94  
Do objections  
letter  
TAC

The following comments are in response to Mountain Cement Company's submission for public notice their proposal to mine Amendment 298C-A7 of mine permit 298c

Figure 2 Air photograph of the Area "C" mine area and Etchepare 7a showing fractures in the mining areas.

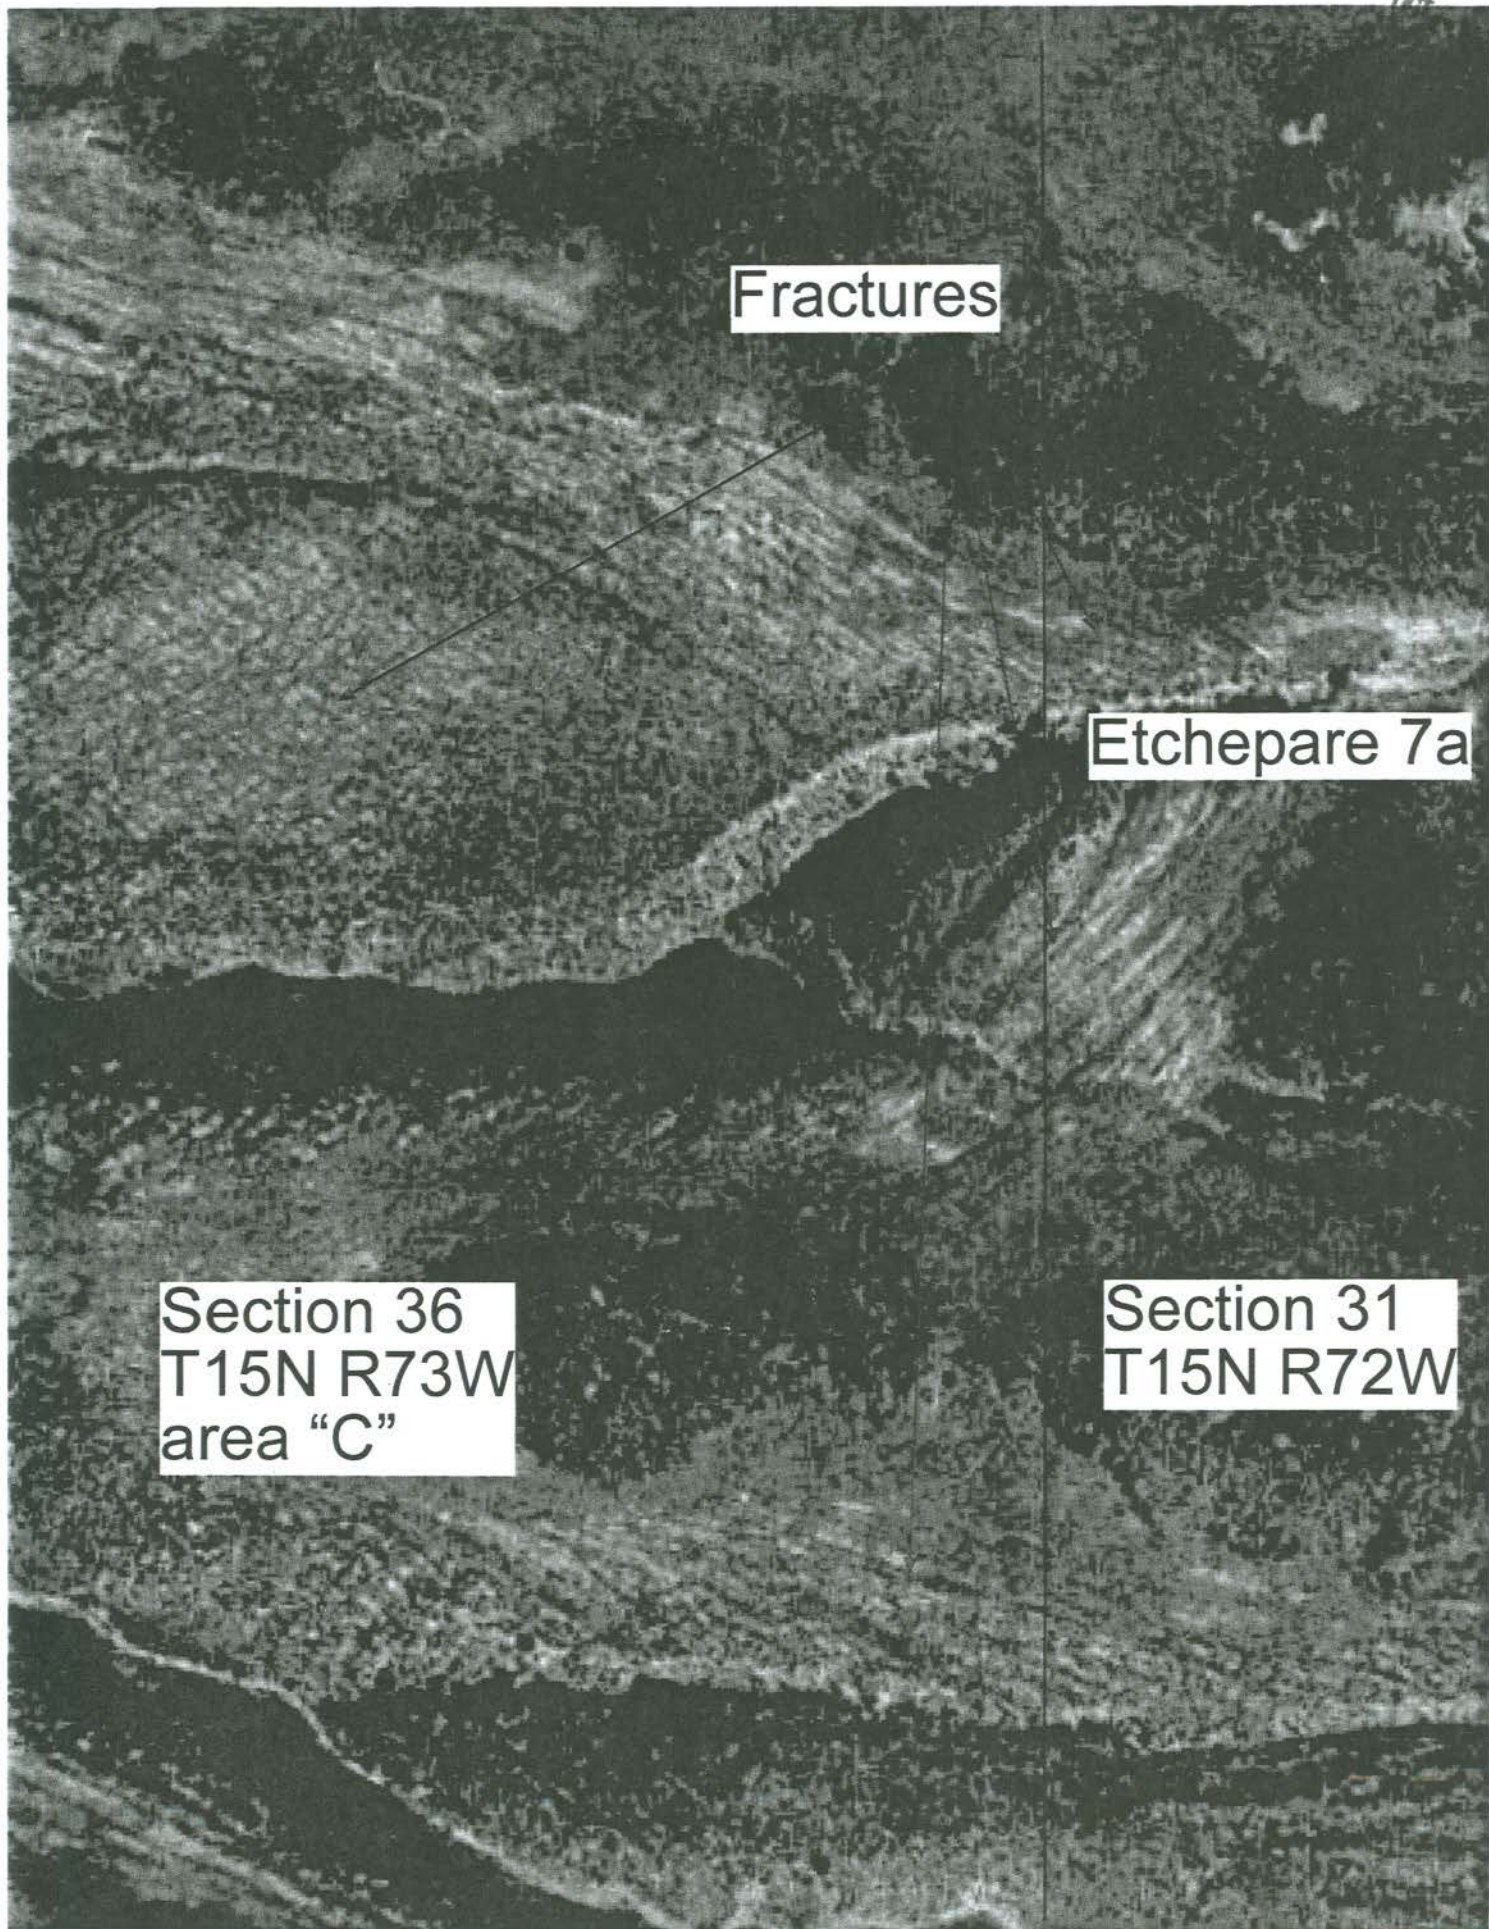
4. It is stated on Page DVIII5-3 that "*Several faults have been identified along the western flank of the Laramie Range in the Etchepare amendment; however, none have been identified in the proposed limestone expansion permit*". Though no faults are known for the proposed project area, there does not appear to be any discussion on the series of northeast-south and the northwest-southeast trending fractures in this area. These fractures range up to  $\pm 30$  inches wide in the adjacent Echepare quarry with some fractures surfically filled with sand and others completely open after removal of the rock overburden. Who did the geological survey for this area after discovery of the extensive fracturing of this area became known?
